March 11, 2024

TO : All Bidders
FROM : Bob Lavey
PROJECT : Nogales High School New Building and Aquatic Center
Project W2110000AR.41
DSA : 03-122782 / File 19-92
SUBJECT : Addendum 3

DRAWING NUMBER: **P2.3.1**

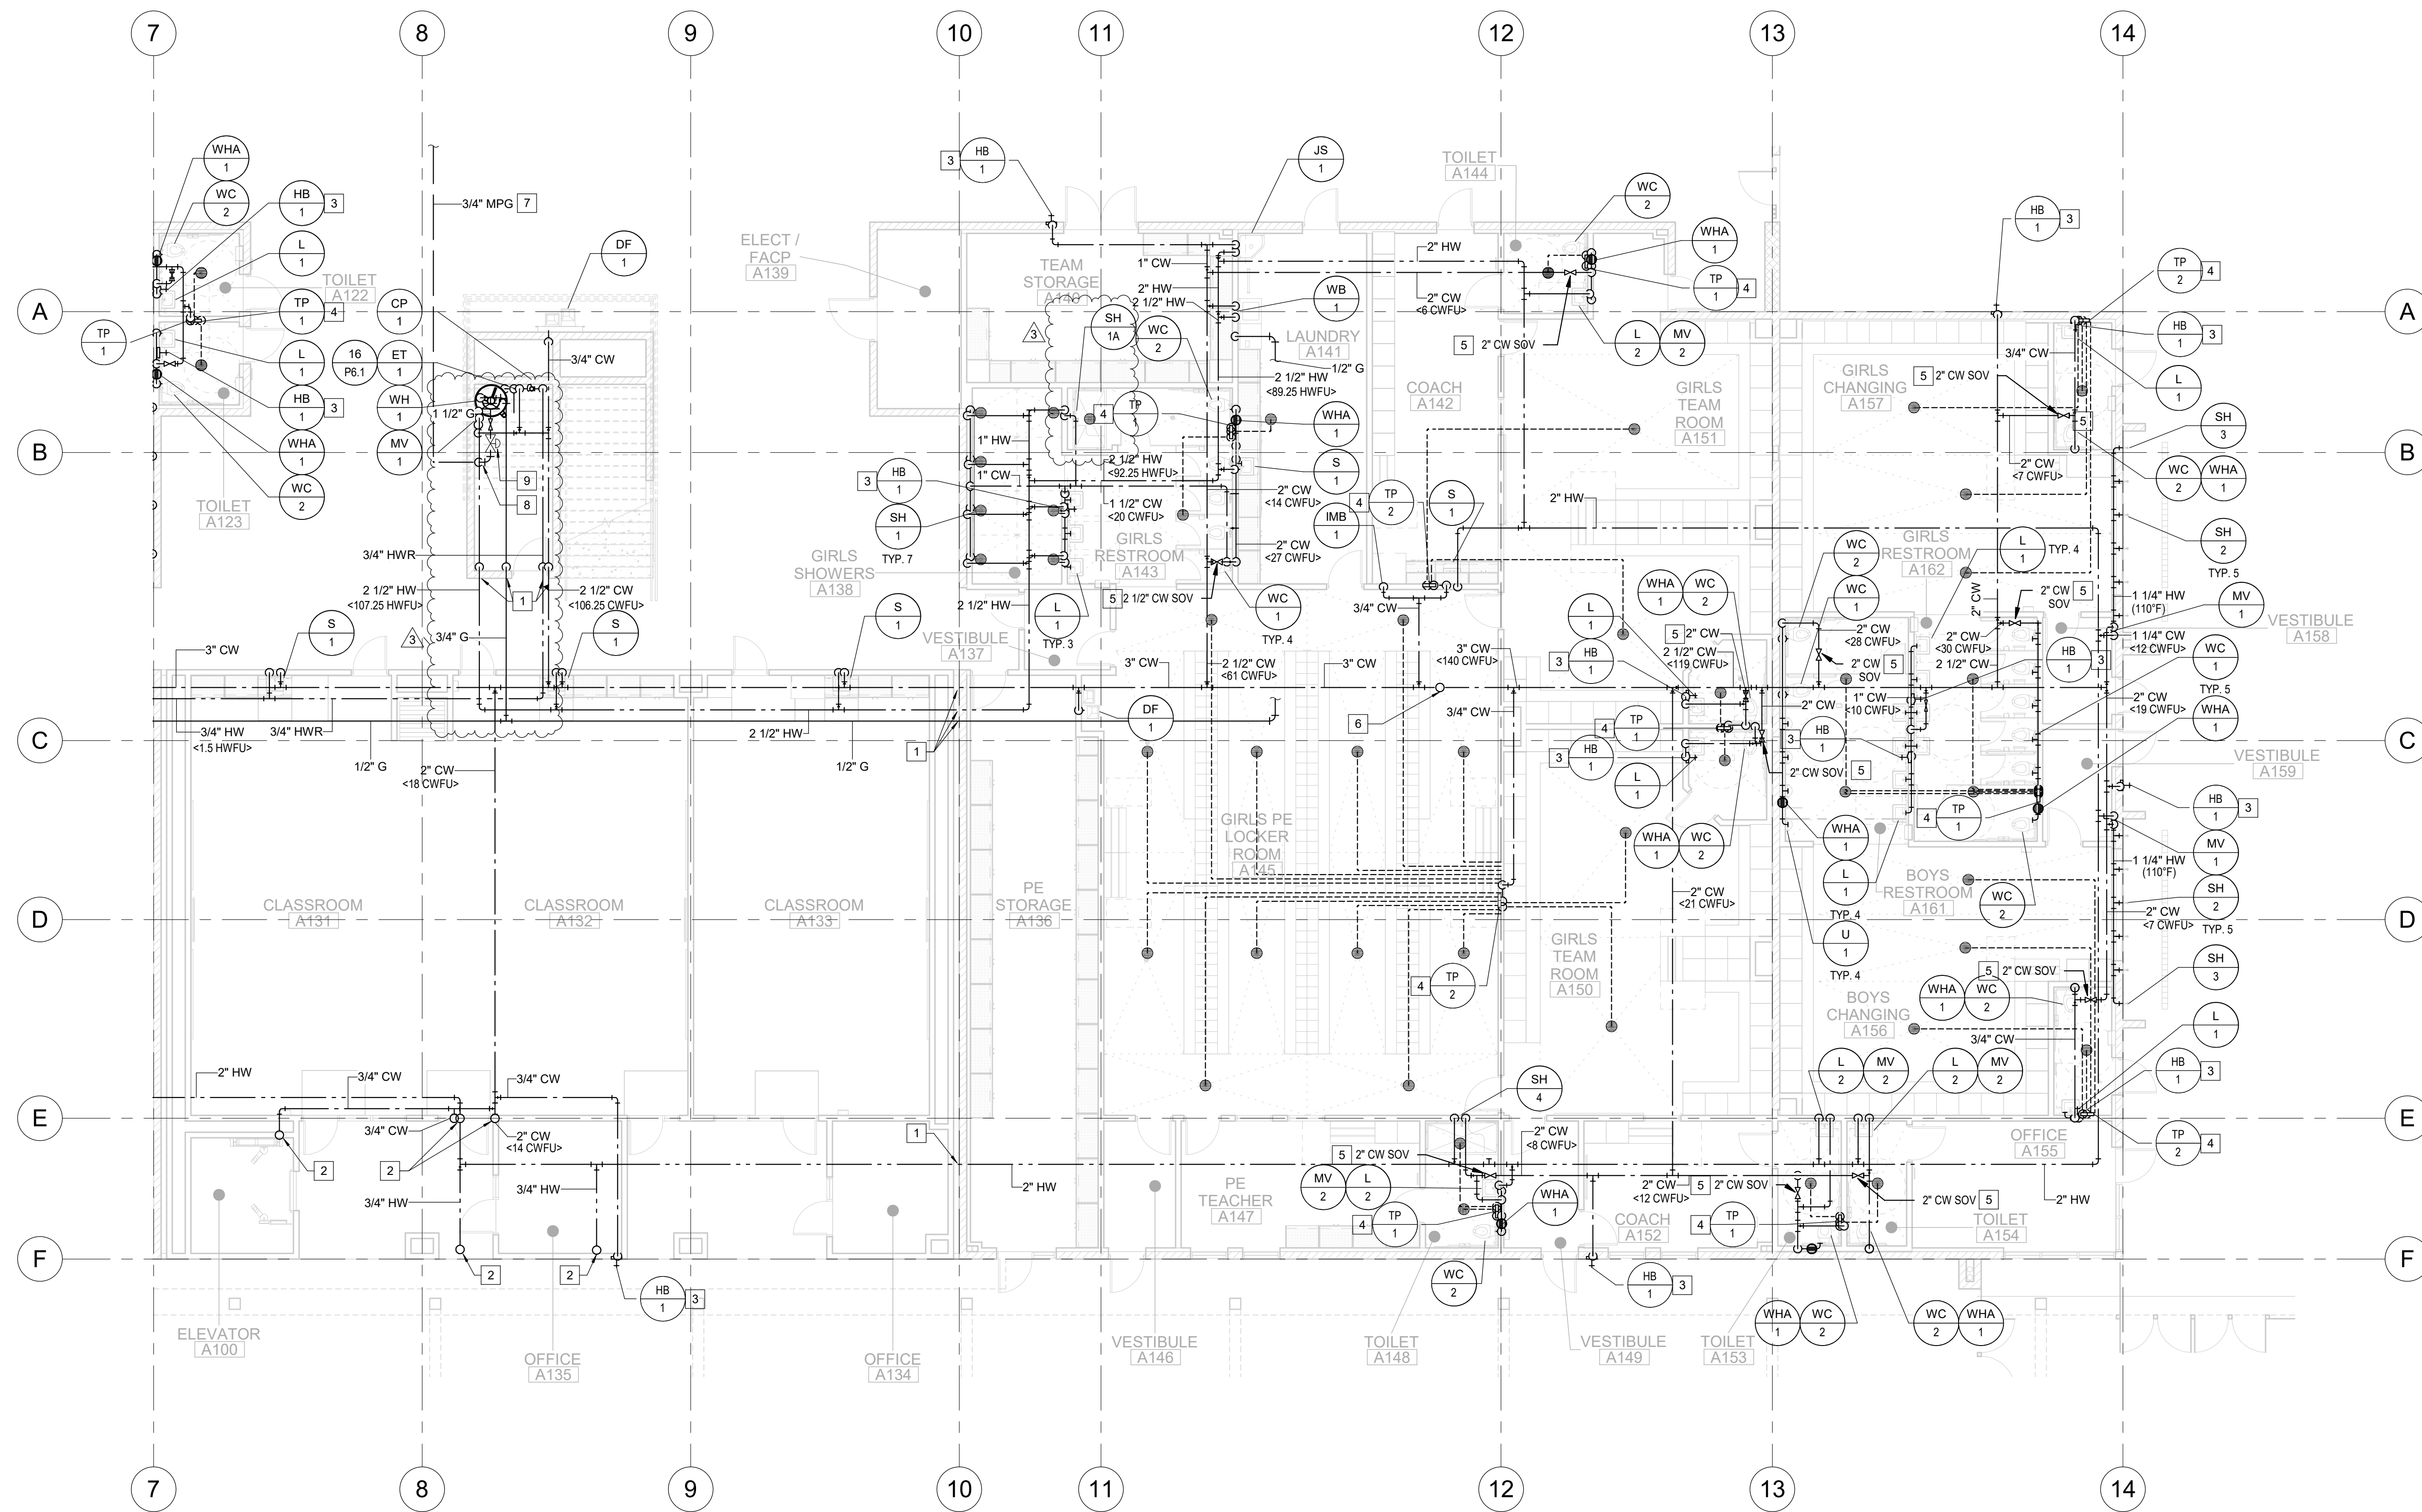
- A. Added keynote 19 per the attached Drawing P2.3.1.
- B. Add 1" vent from gas pressure regulator up through roof. Route to roof similar to water heater vent. Terminate vent through roof similar to Detail 6/P6.2. Locate minimum of 10' away from outside air intake or 3'-0" above.

DRAWING NUMBER: **P2.3.2**

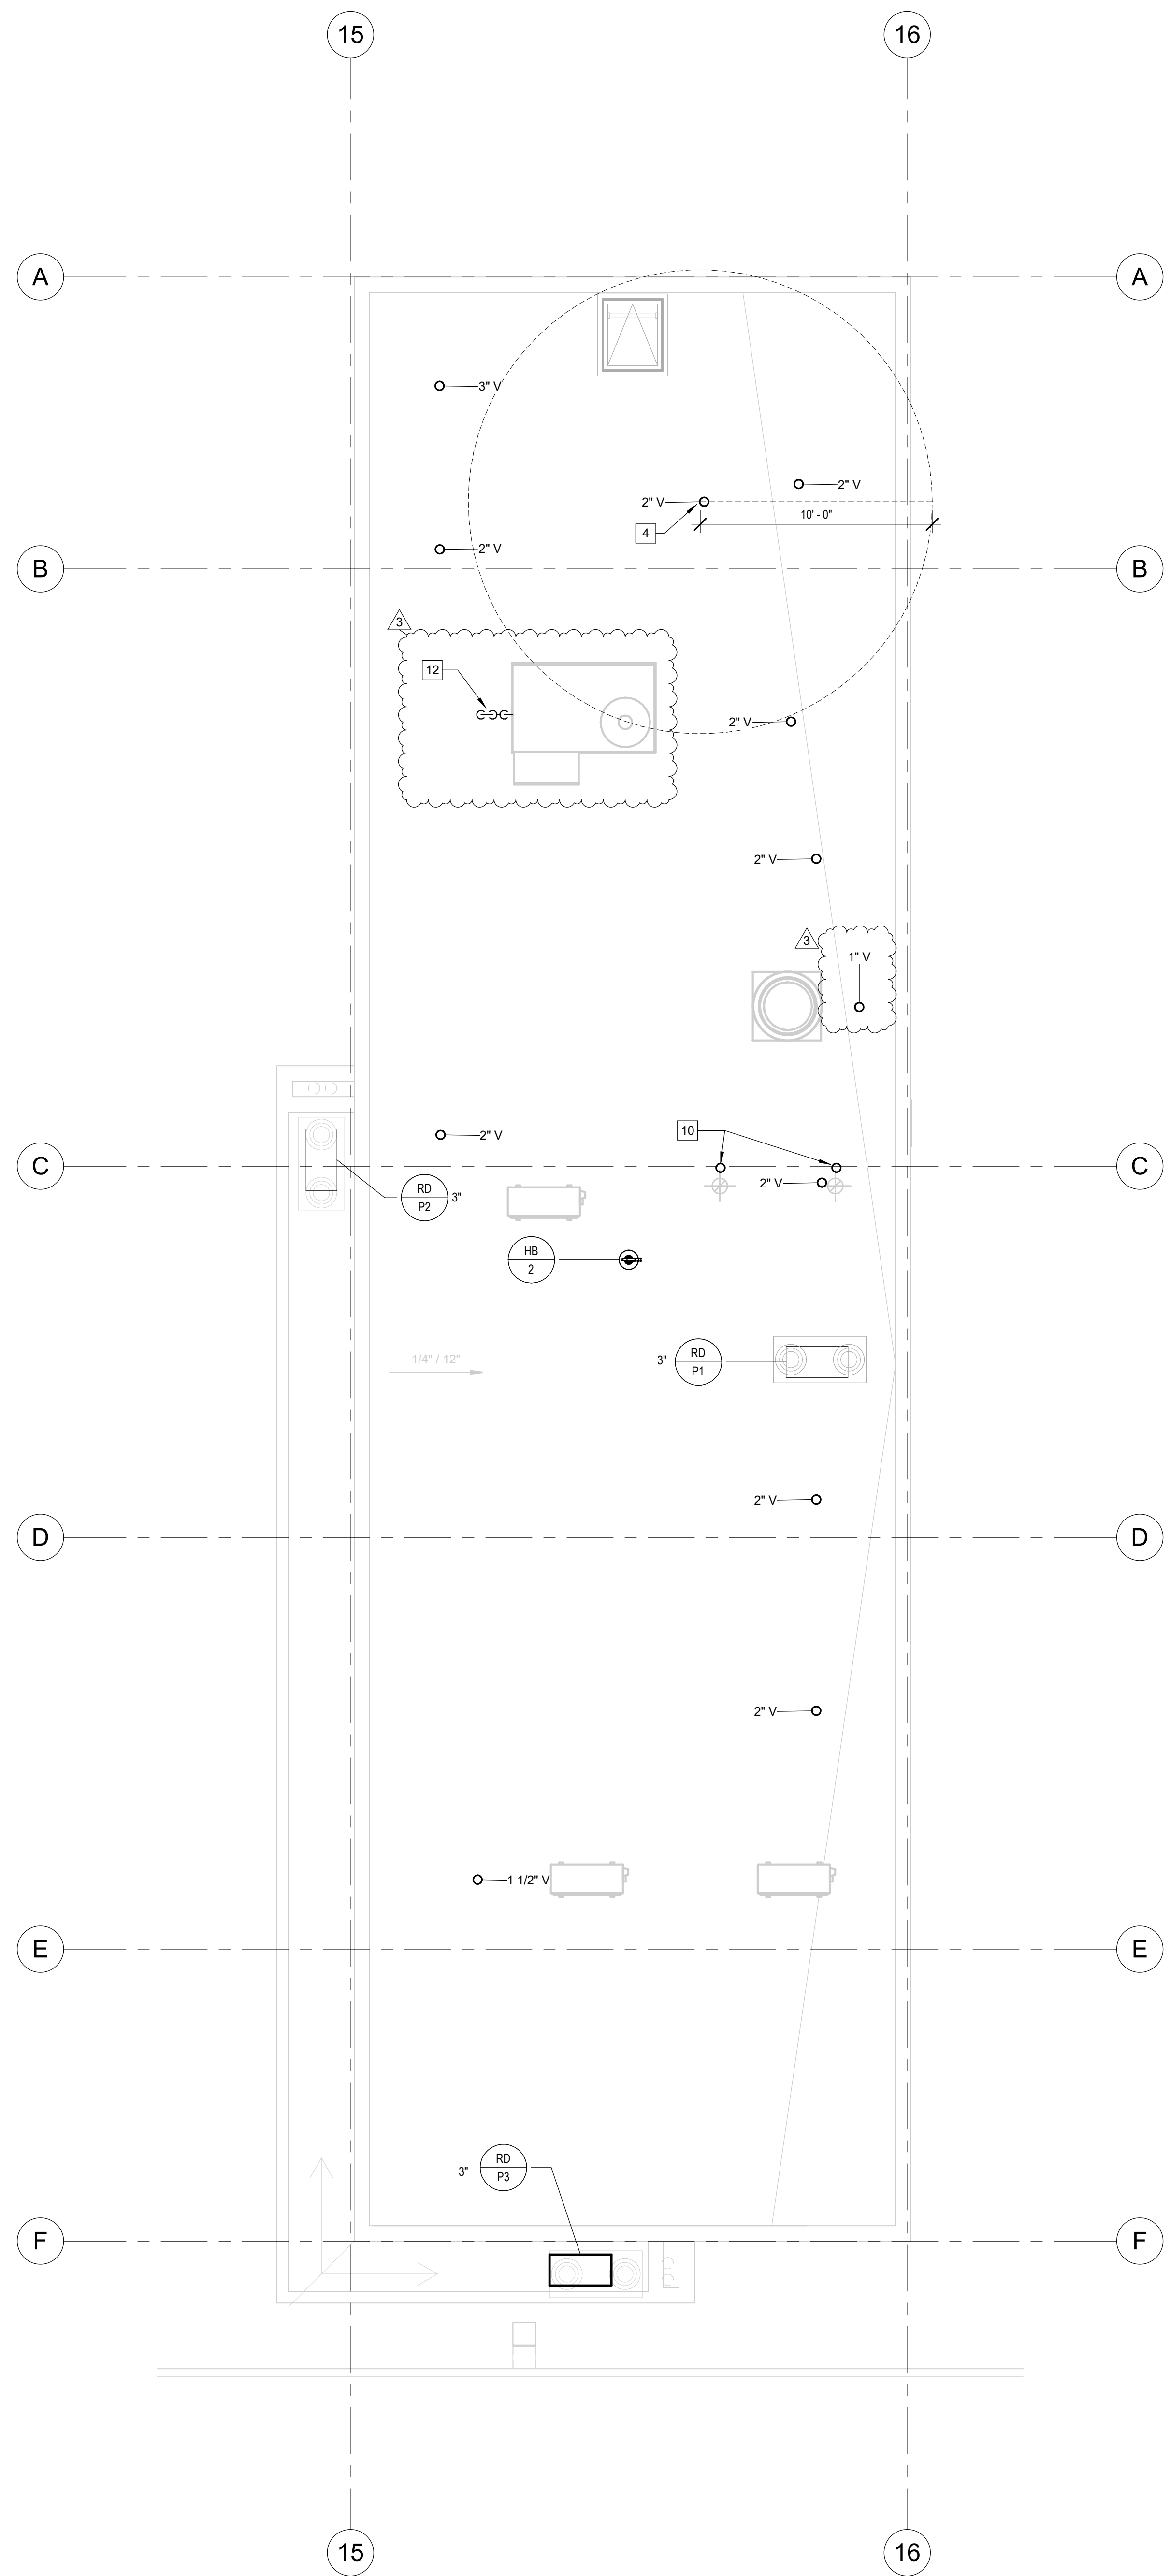
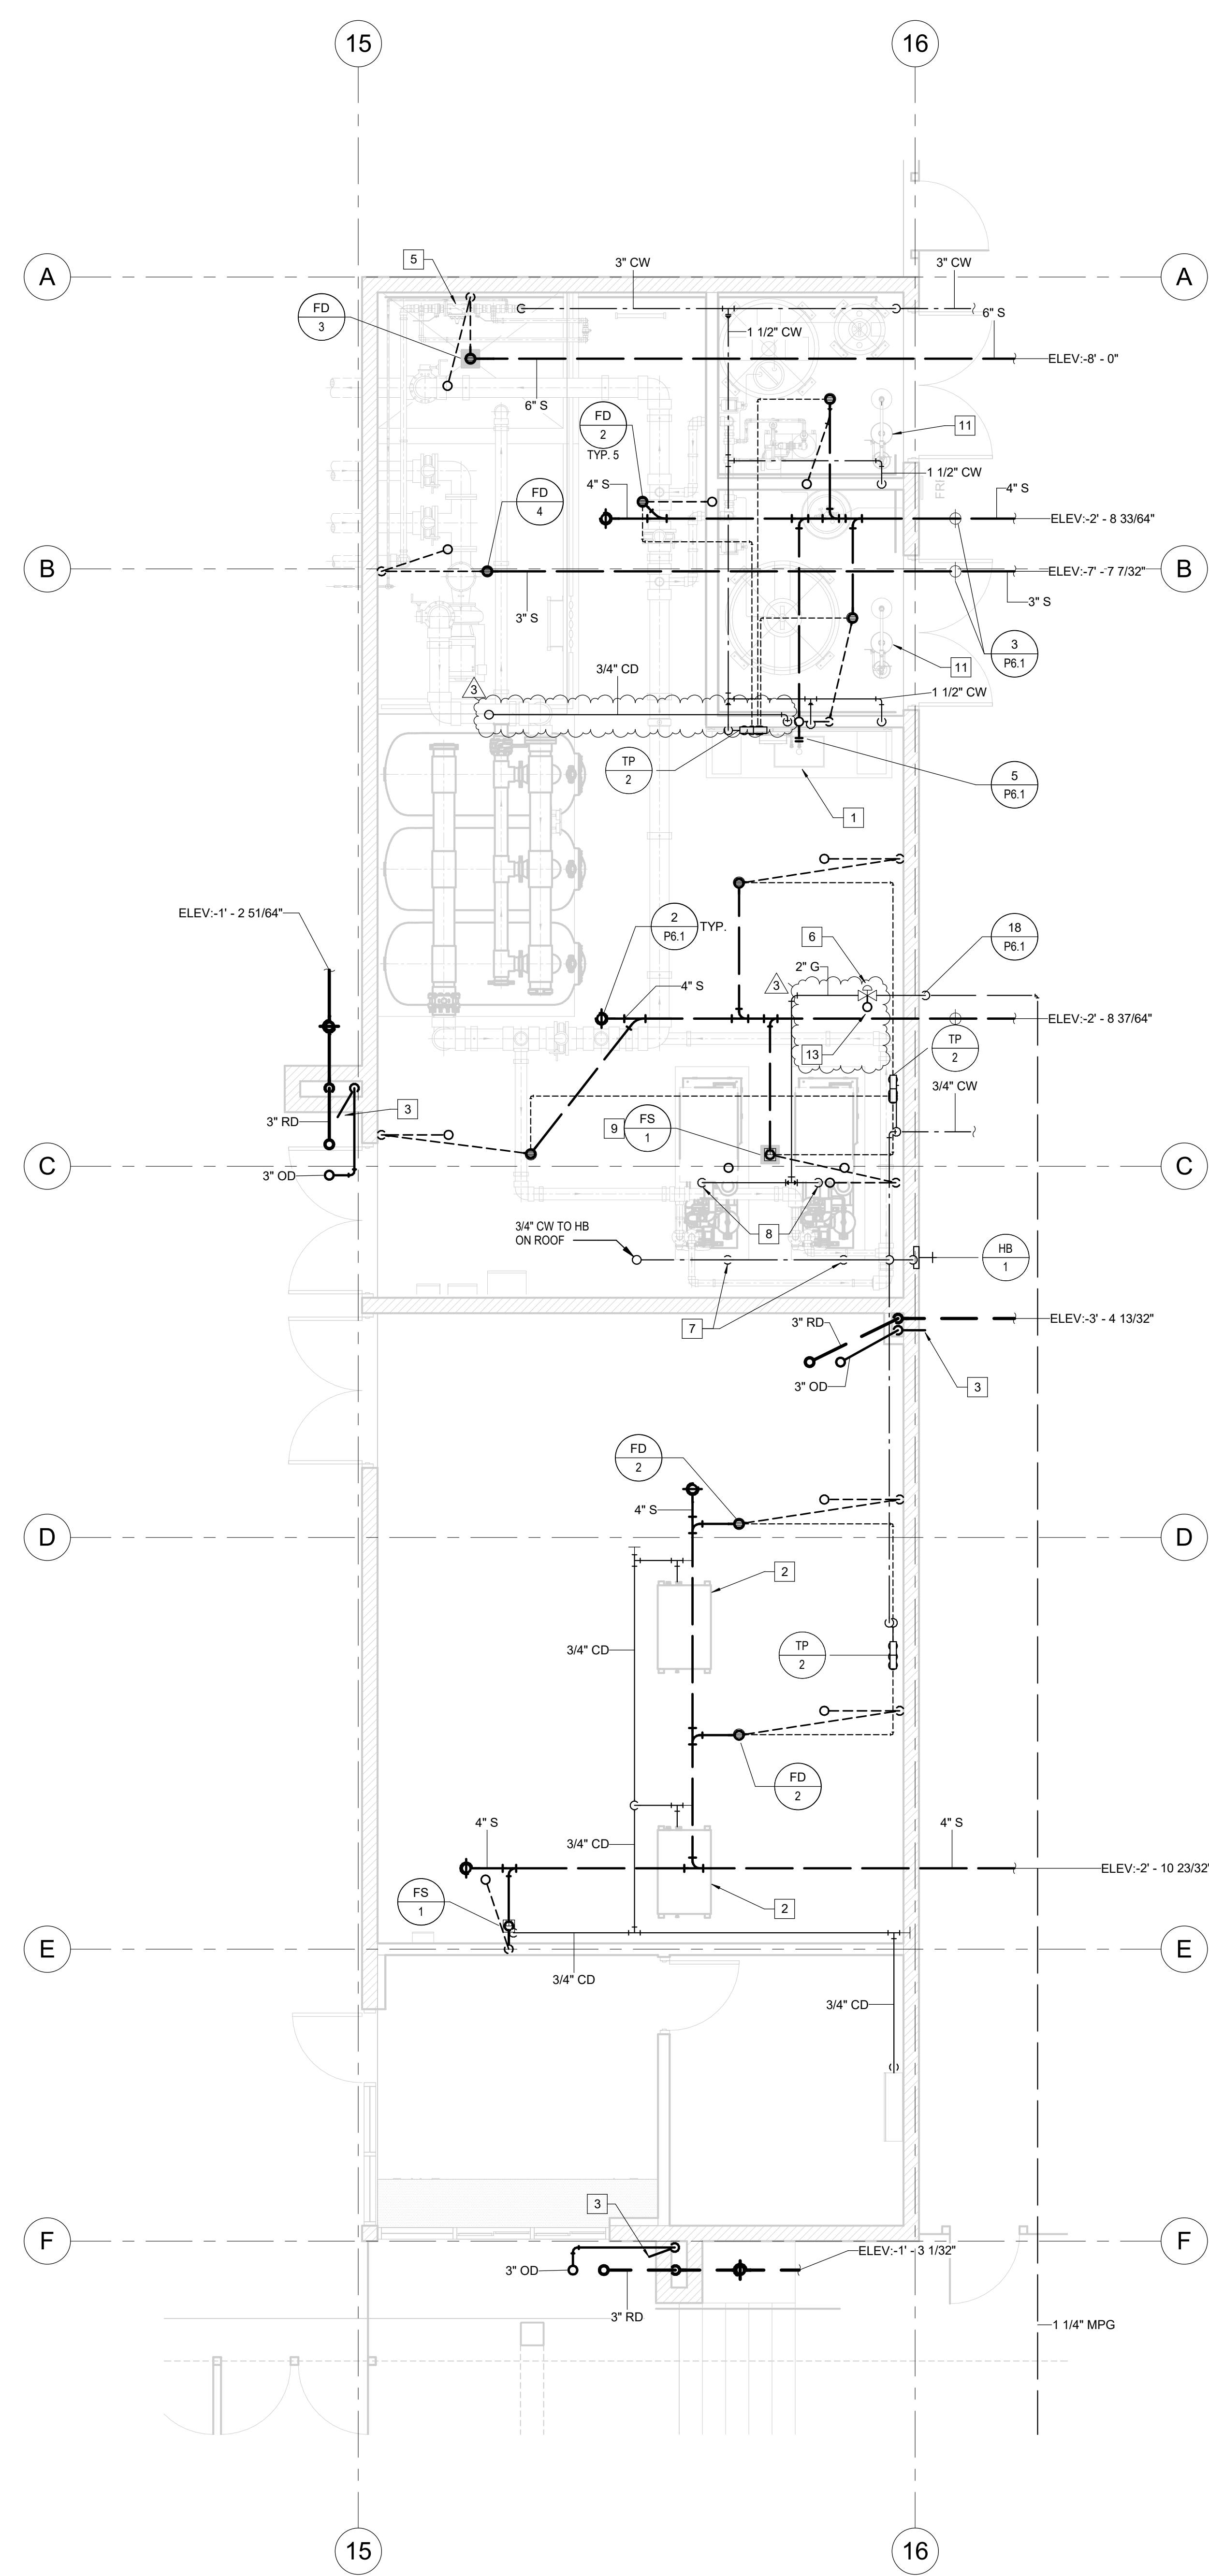
- A. Replace this drawing in its entirety with the attached Drawing P2.3.2.
- B. Gas line increased in size from 1" to 1-1/2", followed by an increase from 1/2" to 3/4" for the line going to the dryers.
- C. SH-4 changed to SH-1A in Girls Restroom A143.
